**PLANNED UNIT DEVELOPMENT &  
SUBDIVISION STAFF REPORT****Date: June 5, 2008**

<b><u>NAME</u></b>	Longleaf Gates Subdivision, Phase One (Revised Plat)
<b><u>SUBDIVISION NAME</u></b>	Longleaf Gates Subdivision, Phase One, (Revised Plat)
<b><u>LOCATION</u></b>	North side of Girby Road 1800'± West of Rue Preserve, and extending Northwest to Lloyds Lane.
<b><u>CITY COUNCIL DISTRICT</u></b>	District 6
<b><u>PRESENT ZONING</u></b>	R-2, Two-Family Residential District
<b><u>AREA OF PROPERTY</u></b>	137 Lots/36.6± Acres
<b><u>CONTEMPLATED USE</u></b>	Planned Unit Development Approval to amend a previously approved Planned Unit Development to allow a private street, gated subdivision, with reduced lot sizes, reduced front yard and side yard setbacks, and increased site coverage, and Subdivision approval to create 137-lots and two "Future Development areas".
<b><u>TIME SCHEDULE FOR DEVELOPMENT</u></b>	<i>Phase One:</i> Roads constructed, with home construction anticipated to begin immediately upon Commission approval;

# SITE PLAN

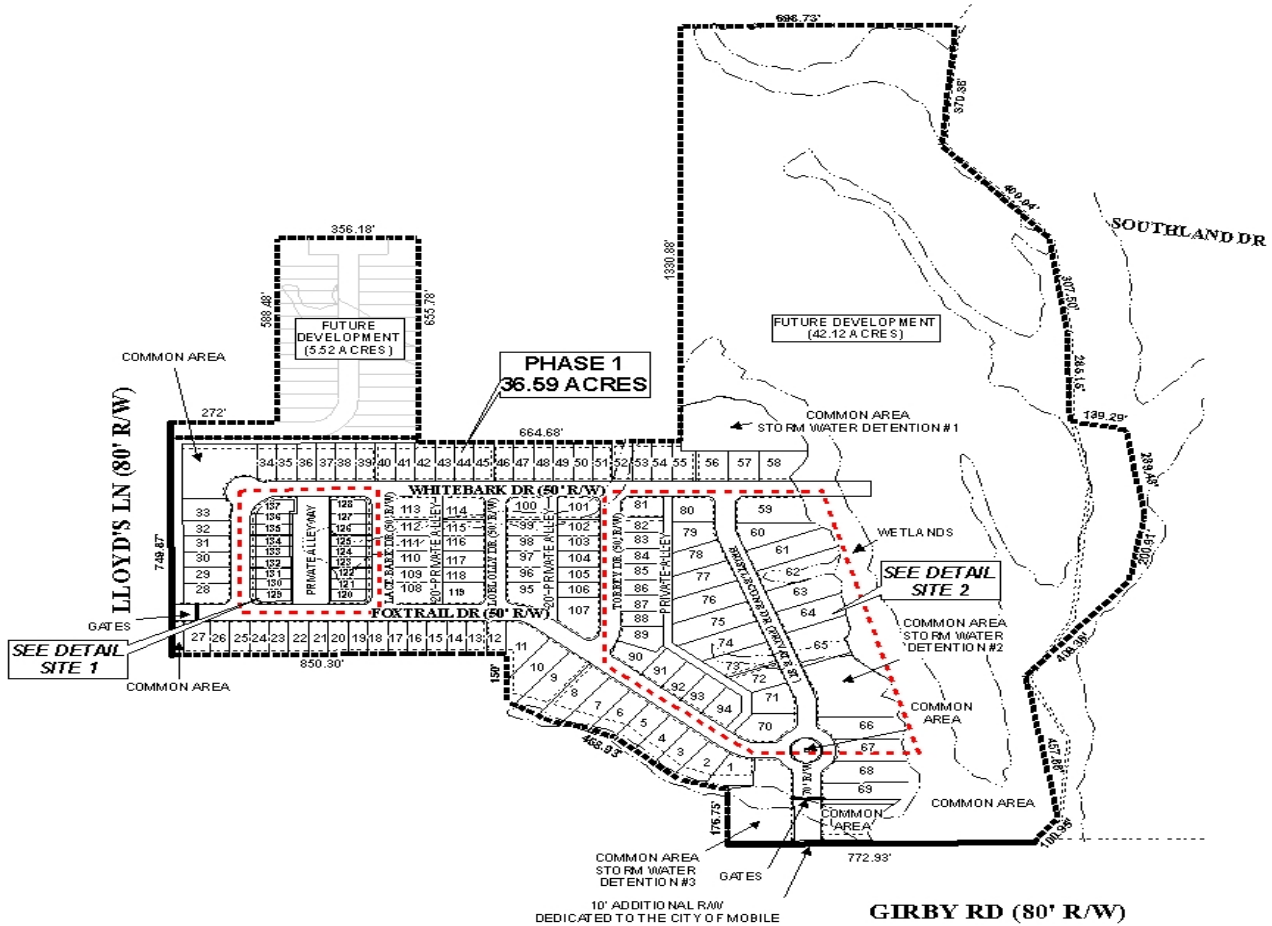
It should be noted that a slight change in the plan to reduce two alleyways in the previously approved Subdivision and Planned Unit Development (PUD) applications necessitates the resubmittal and approval by the Commission. Whereas, the change is considered slight all departments that reviewed the previous applications require review and comments to these changes so that the changes meet the minimum requirements of all codes and ordinances.

It should be noted that minor modifications to a previously approved Subdivision and Planned Unit Development (PUD) require the resubmission and approval by the Commission; however, the change in the reduction of two alleyways by 5-feet and 2-feet have no impact on these issues and may be referenced in the **June 5, 2008** staff report. Therefore, all conditions of approval in the recommendations of the Subdivision and Planned Unit Development (PUD) reflect the conditions of approval of the previously approved Subdivision and Planned Unit Development (PUD).
